## **Global Technical Regulation No. 7 (Head restraints)**

### **OICA position on head restraint height**

Document ECE/TRANS/WP.29/2013/17 proposes to increase the height of front outboard head restraints from the current 800 mm to 830 mm.

**Figure S.2: Percentage probability of mitigating long-term neck injury based on head restraint height and backset for the UK male population**

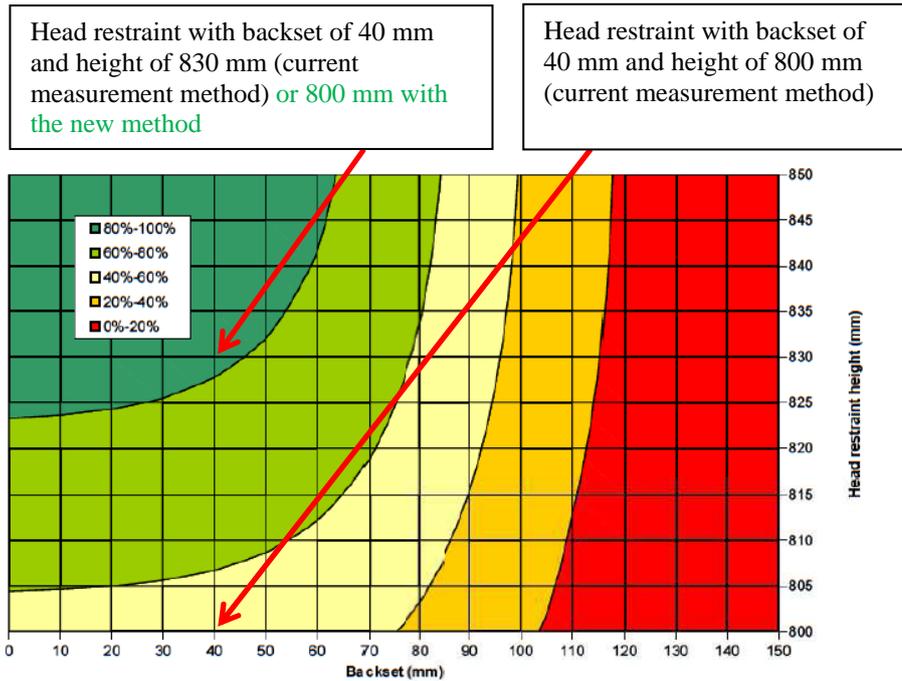
In particular, a graph (see below) summarises the injury-mitigation potential (in other words the safety benefit) of backset/height combinations. OICA herewith stresses that the head restraint heights mentioned in this graph are based on the current measurement method. Taking into the fact that simply changing the measurement method would require head restraints to be higher, it is clear that this simple change of measurement method would give results in the dark green area (80-100% probability of mitigating long term neck injury).

This means that if GTR7 is amended by incorporating the new measurement method and retaining the 800 mm limit, all head restraints meeting the requirements would be at least as good as the point indicated in the graph (dark green area).
